LANDSCAPING REVIEW**BACKGROUND –**

Peter Erb, Zoning Administrator.

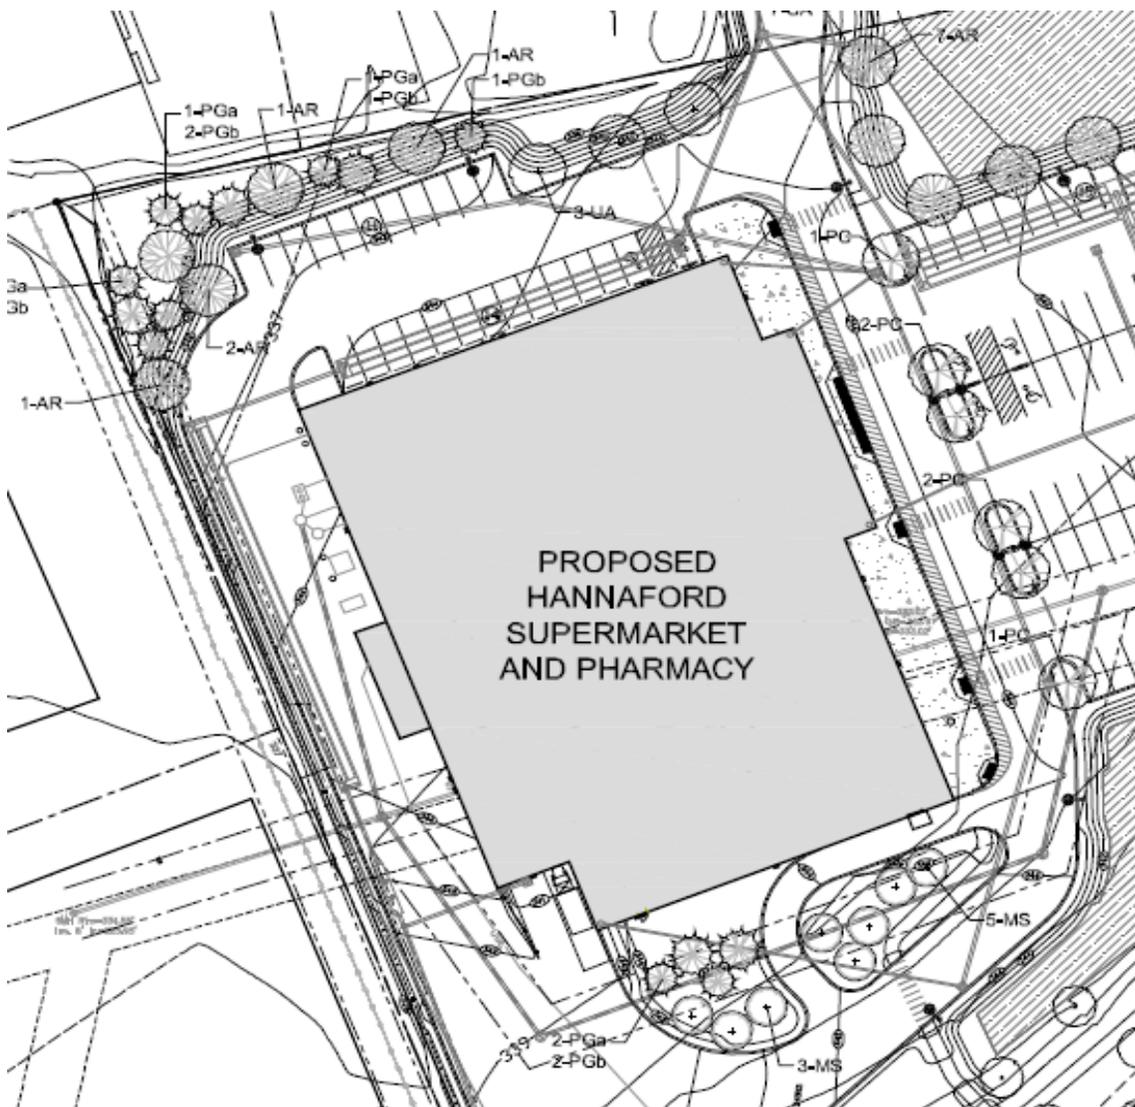
In the plan, below, the trees at the very top are red maples, the rest, labeled PC, are Chanticleer pear. The area of the trees shown on this plan is the average mature spread they will achieve.

- The tree species Chanticleer pear is not a large canopy tree species. It has an average maturity height of 40 feet and a spread of 20 feet, not well suited to provide the shade and glare reduction. It is a variety noted for a pyramidal shape, narrower than other ornamental pears, chosen for areas where lateral space to spread is limited. See end of document for specifics.
- The larger red maples are located on the north side of the parking area, not providing shade at all.
- There are no trees on the southern side of the parking area, and none within the majority of the parking lot itself.
- The spread of the trees in the plan is indicative of the shade they provide at noon in mid summer. While obviously more shade will be provided at other times as the angles of the sun change, almost none of the parking spaces actually are receiving shade.

- This development will be located on a raised platform of fill above the native soils, and all the perimeter trees around the parking lot are located on the outer slopes of this platform. The planting specifications are calling for an area to be excavated twice the diameter of the root ball or container, approximately four feet in diameter. The earth surrounding this excavated hole must be of a soil mixture, not over compacted, and area suitable to nourish a mature tree, and if the pears are deemed unsuitable shade trees, a sufficient area for the larger tree species. This same issue applies to any trees in the islands. At this point the applicant maintains that the area shown on the planting specifications is sufficient for a mature tree.

- The 50% slope of the above planting location is not reflected in the landscaping boiler plate details L 3 which is for flat situations. Some type of retaining wall is required to insure that the soil doesn't slope down on to the tree trunk in the future.

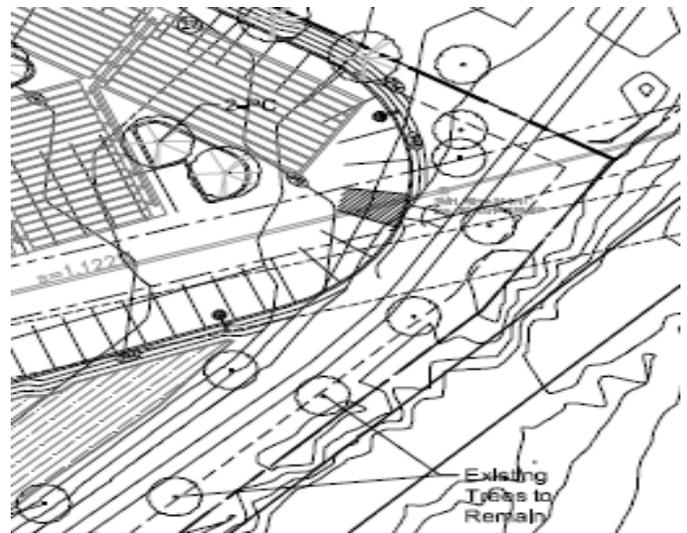
Section 5.6.5 requires that landscaping shall visually screen expanses of pavement and between incompatible uses. The plan to the right is the corner of the parking lot nearest the post office. The parking lot comes within ten feet of the recreational path. At this point no plantings have been proposed, and some existing trees have to be removed to accommodate the parking area.

- The challenge is to adequately screen the parking area from the public recreational path without creating a solid wall of vegetation, which visually would destroy that portion of the path, and as well could create security concerns because of the presence of the heavy vegetation immediately adjacent to the path.
